Sydney Olympic Park New High School

Architectural Response to SDRP Report

Physical and visual connectivity

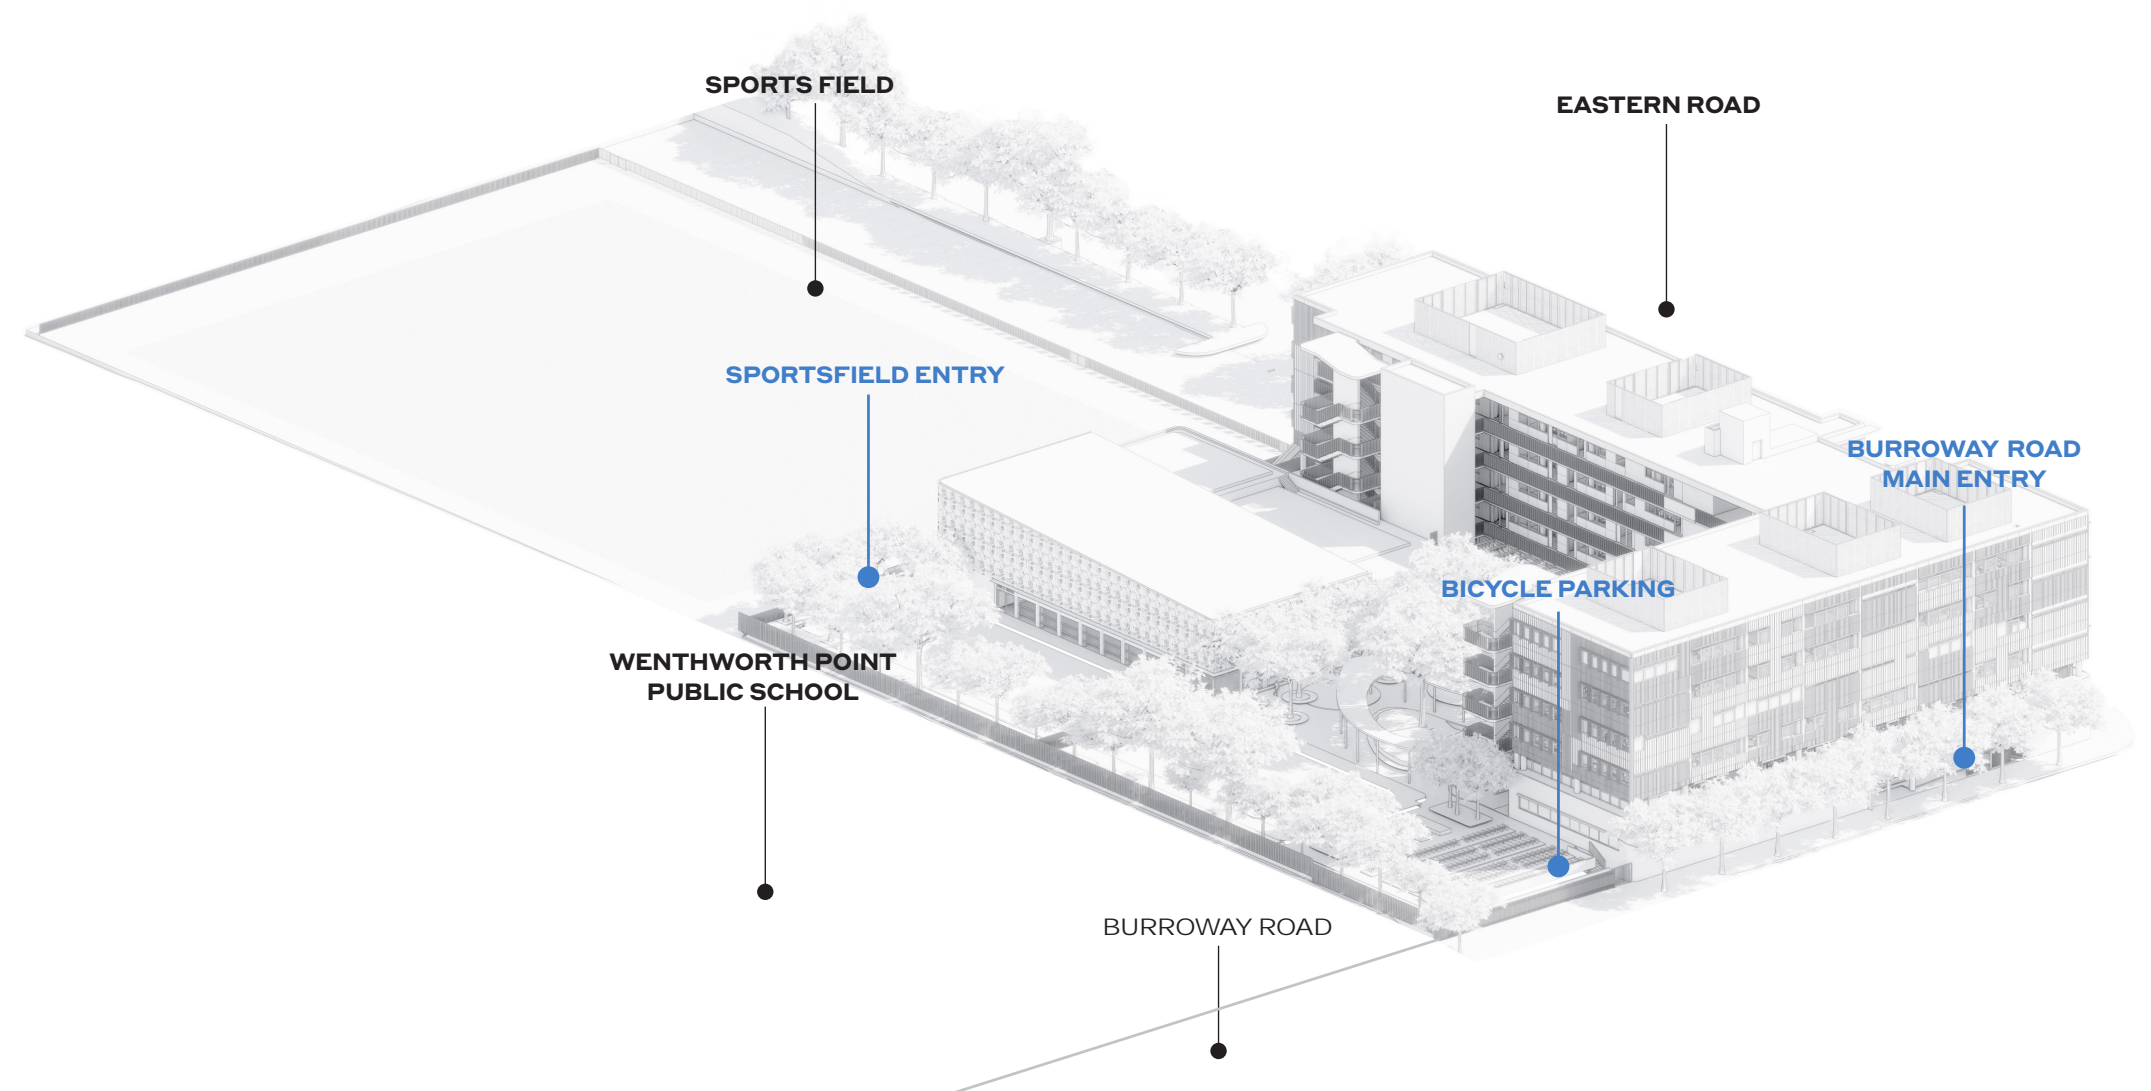
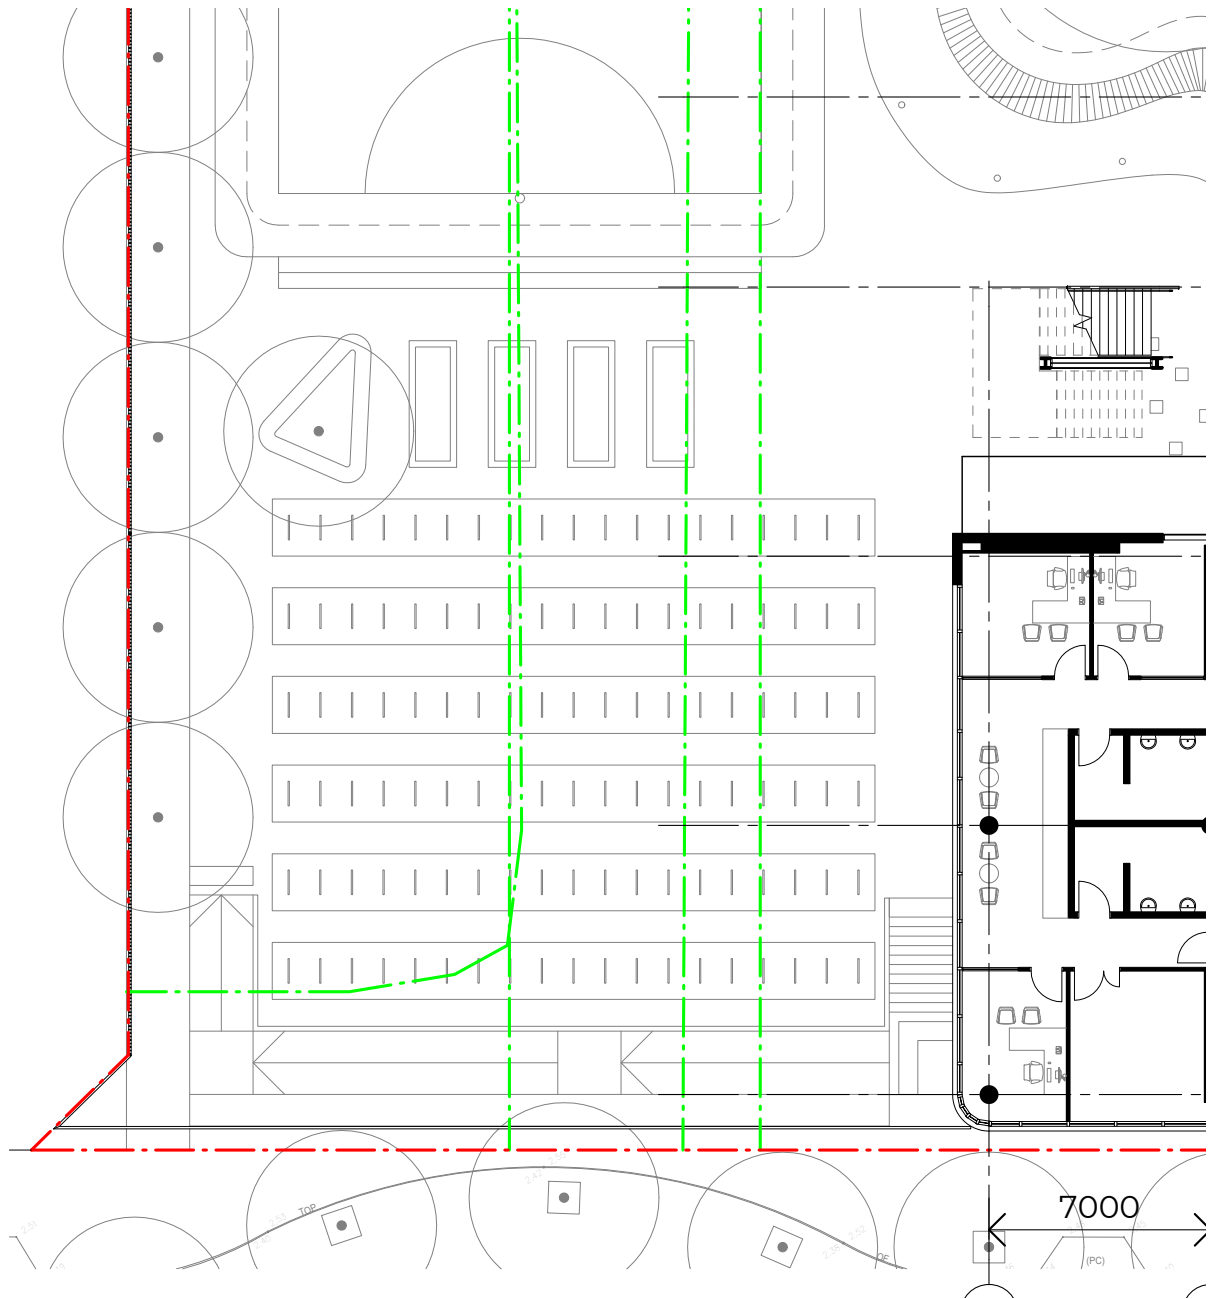
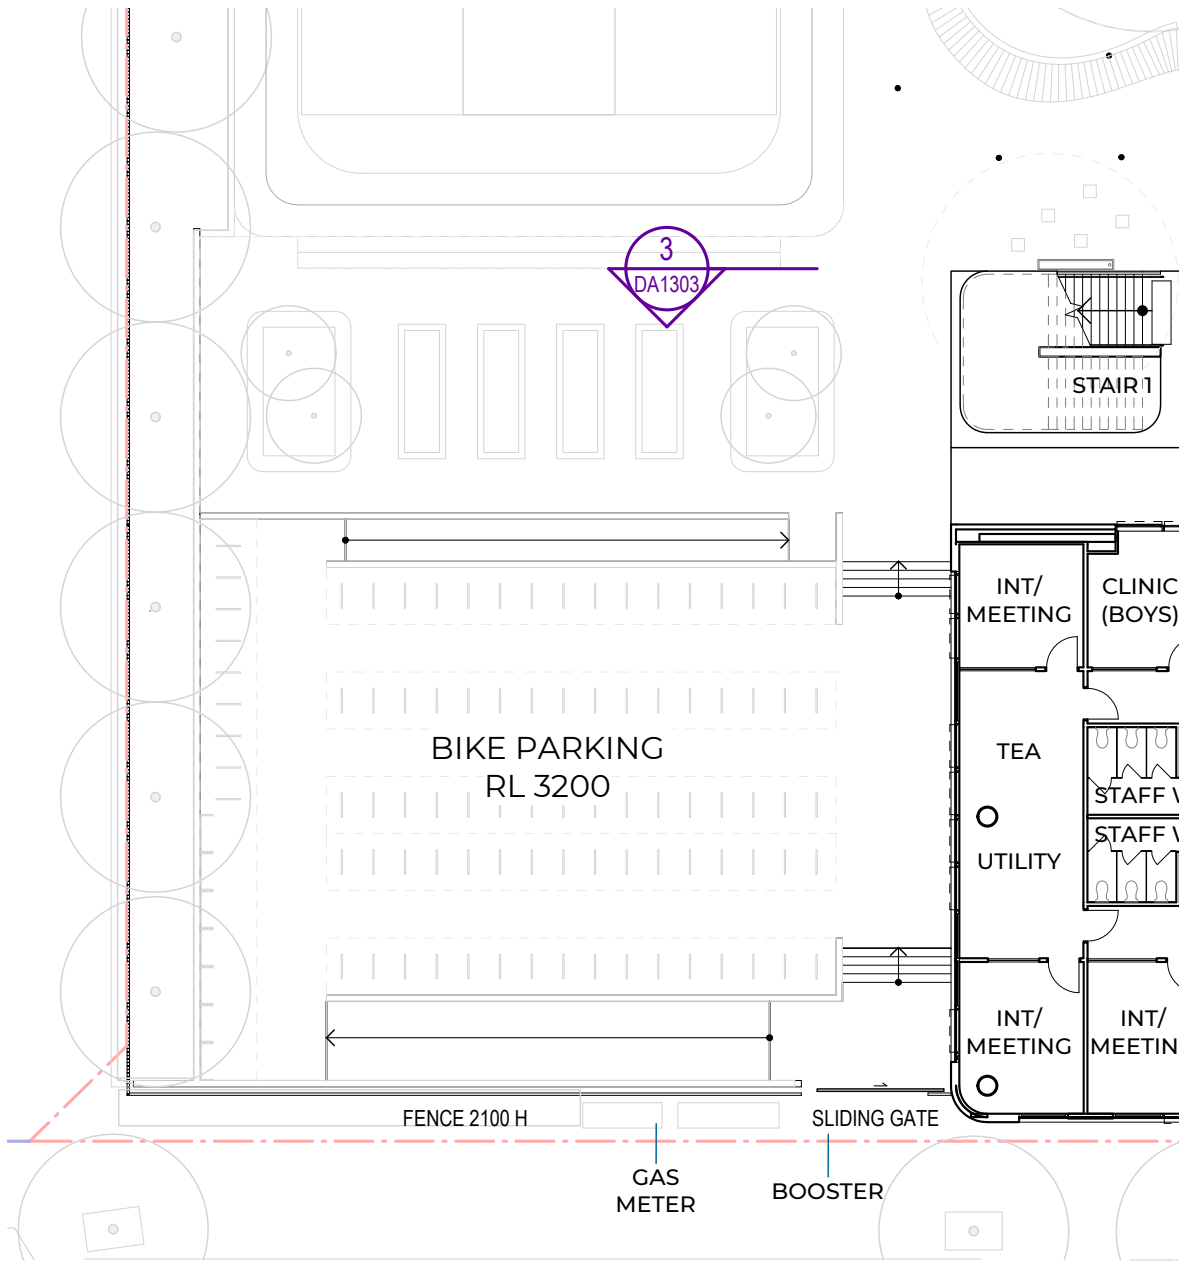
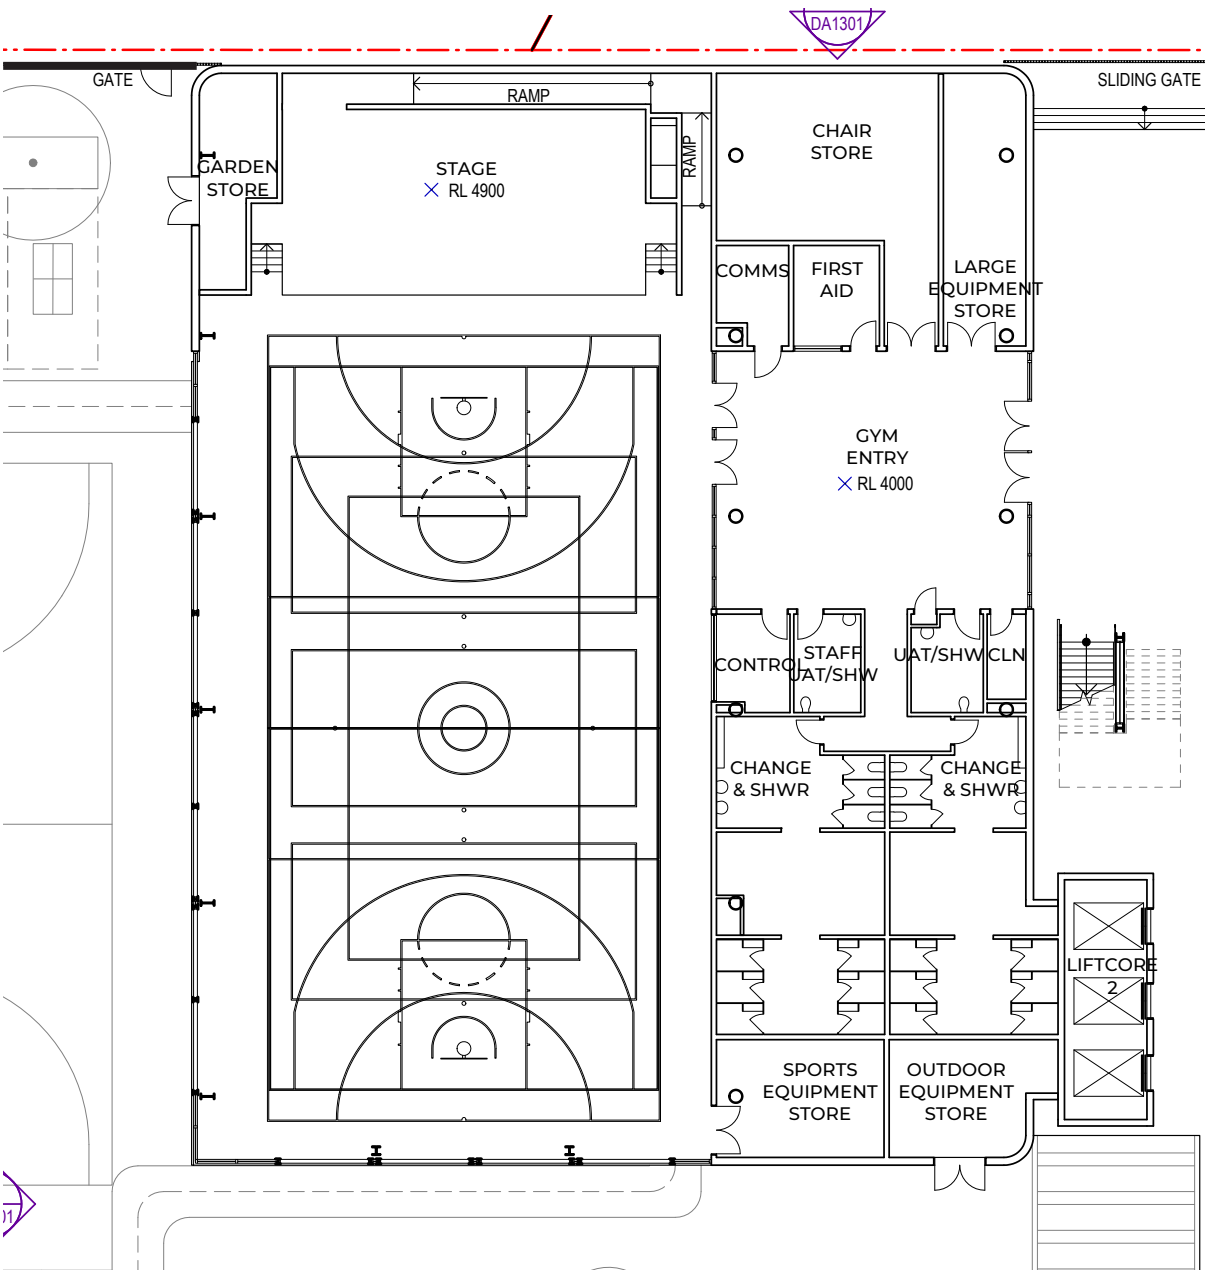
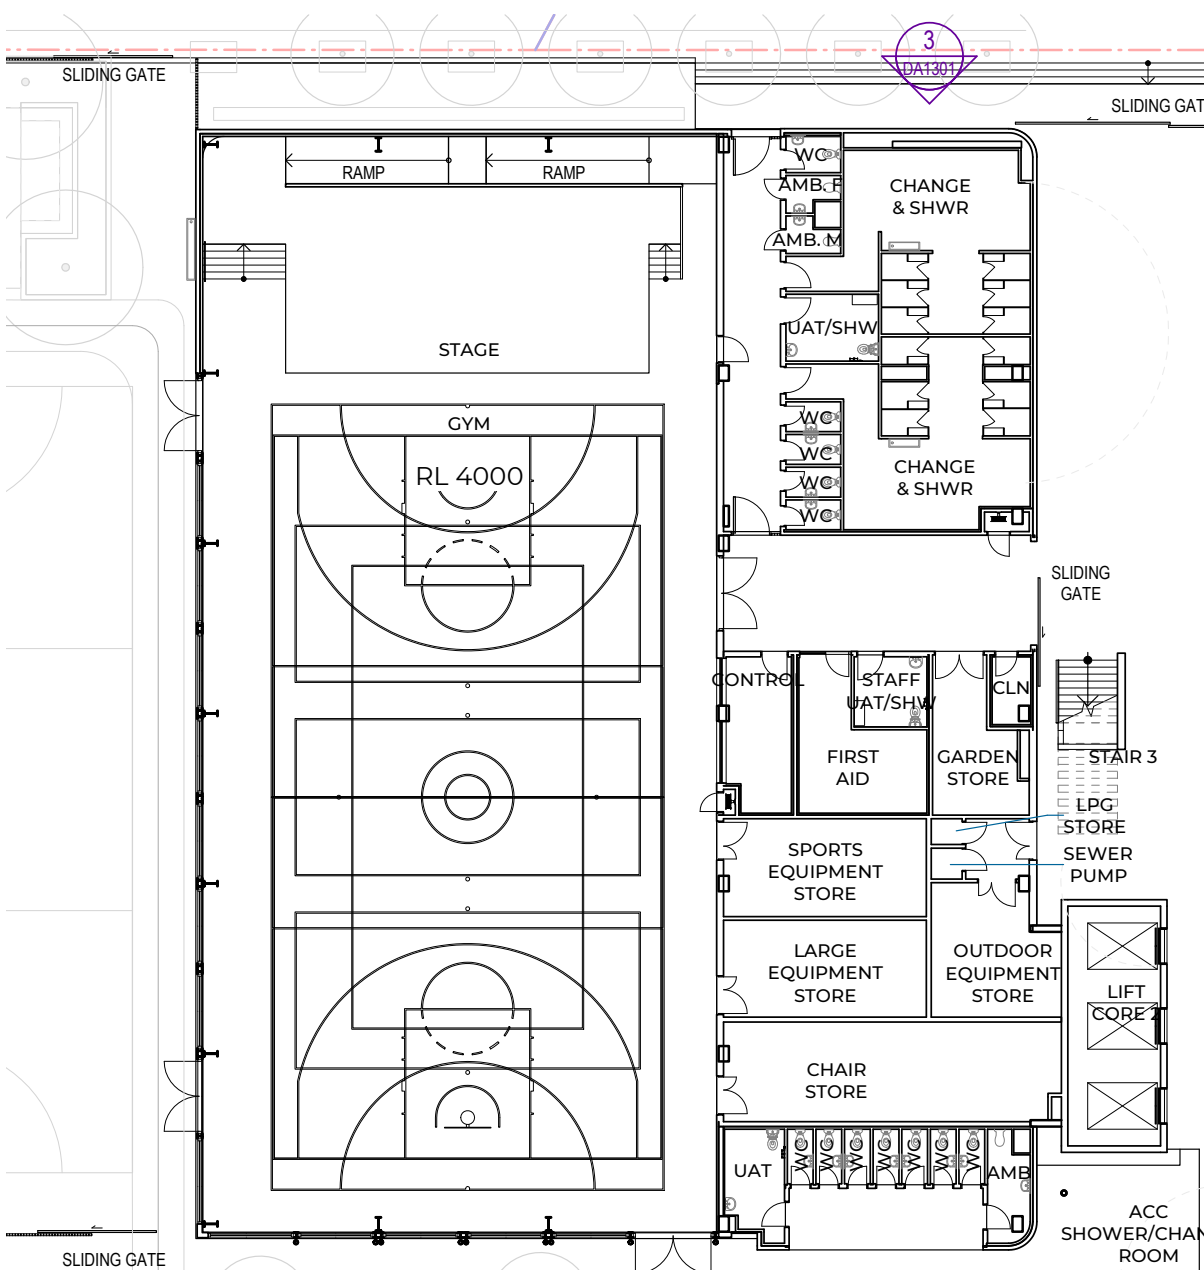
Comment: Access and connectivity – Illustrate the physical and visual connections through the school site for both the school community and the external community.

Architectural and landscape elements along school's perimeter have been shifted to enhance physical and visual connections between the school and its urban context, and to provide optimal flexibility and usefulness in operation.

As noted in the response to item E9, the width of the undercroft opening onto the school courtyard has been more than doubled, significantly increasing views through the space.

The bicycle parking facility at the south-western corner of the site has been physically lowered, halving the height of the retaining wall required on the footpath edge and promoting views to the playground beyond. Physical access to the bicycle store has been widened to better serve students entering the school in this location, and the mitigate the risk of collisions between cyclists and pedestrians.

The gym and northernmost sports court have been re-configured to facilitate controlled access to these amenities outside of school hours. A fence and sliding gate have been added between the western boundary and gym building. During school hours, the sliding gate is held in open position to maintain a unified playground for students. After hours, the sliding gate is closed, and a second gate on the boundary with the sports field can be opened to give access to the sports court. In this mode, the gym can remain secure, or can be made accessible as well.

The change rooms and toilets attached to the gym have been rearranged to allow similar flexibility

of use. These facilities are placed along a corridor with lockable doors at each end, one of which opens directly onto the sports field. On weekends and after hours, the field-side door can be opened to permit access to the change rooms and toilets, while the other door remains locked to secure the rest of the school grounds.
